**TOMARK, s.r.o.**  
Strojnícka 5  
080 01 Prešov

# SERVICE BULLETIN

**No:** SB\_SD4-01-2020

<b>MODEL AFFECTED:</b>	EASA-TCDS No. EASA.A.606, Issue 3, 01.April 2019										
<b>APPLICABILITY:</b>	<p>It is not mandatory to retrofit engines which are currently equipped with old type oil hoses. It is recommendation to be done those if any higher level of use than standard is observed during respective aircraft maintenance.</p> <p>In case of interchange/repair/maintenance it is not allowed to exchange individual types of hoses. Mixing of oil hoses types is not allowed. All oil hoses must be of the same type for the entire engine.</p> <p><b>Note:</b> During the closest oil hoses replacement prescribed every 5 years by MAINTENANCE MANUAL (LINE MAINTENANCE) FOR ROTAX (R) ENGINE TYPE SERIES /5/ valid issue in Chapter: 05-10-00 <u>TIME LIMITS</u> Section 2) Time limit Paragraph 2.1) Time limit for rubber parts replace the original oil hoses only with new type of oil hoses.</p>										
<b>SUBJECT:</b>	Introduction of Oil Hoses CONTI OLN M4M-2 for oil system of Rotax 912 S2 / ULS2 engines installed on Viper SD-4 RTC and Viper SD-4 Night-VFR aircrafts										
<b>COMPLIANCE:</b>	Impleme

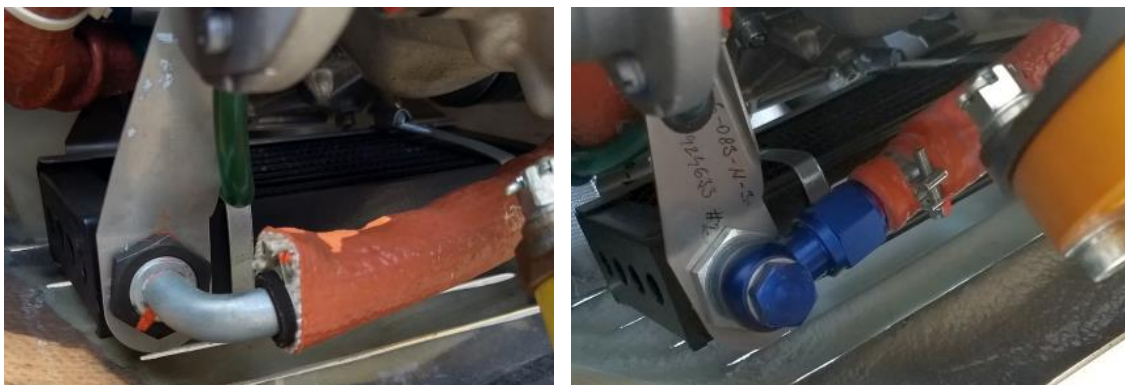
4. Remove plastic (or metal) tightening ties by which oil hoses are mounted to the engine and other engine inhalations.  
**NOTE: Before removing the tightening ties, it is advisable to make a photographic documentation of the method of attaching the hoses for re-attachment after replacement.**
5. Label individual hoses or fireproof sleeves on the hoses by permanent marker yourselves.
6. Sequentially disconnect oil hoses – unwind terminal fireproof tape, release hose clamp and pull ending of oil hose down from respective fitting.

- From the engine output

- From the oil tank input and output

- From the oil radiator output

- From the oil radiator input

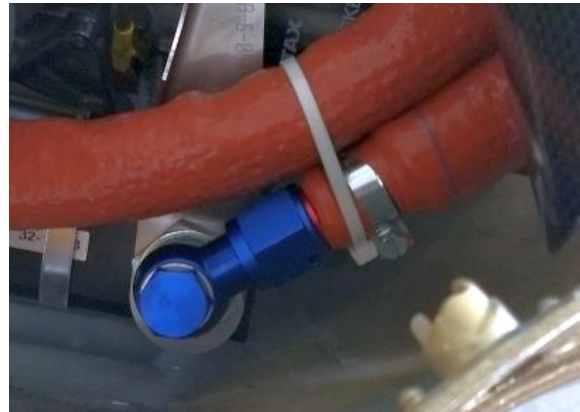
- From oil pump input

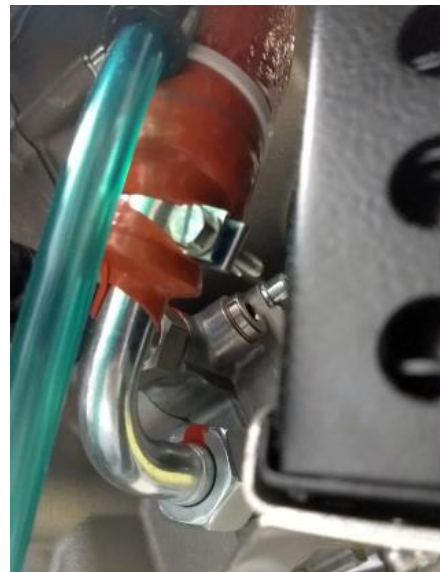
**CAUTION:** During disconnecting hoses (mainly at the lowest oil circuit point) the residual oil could outflow.

7. Dismount oil hoses from the oil thermostat.
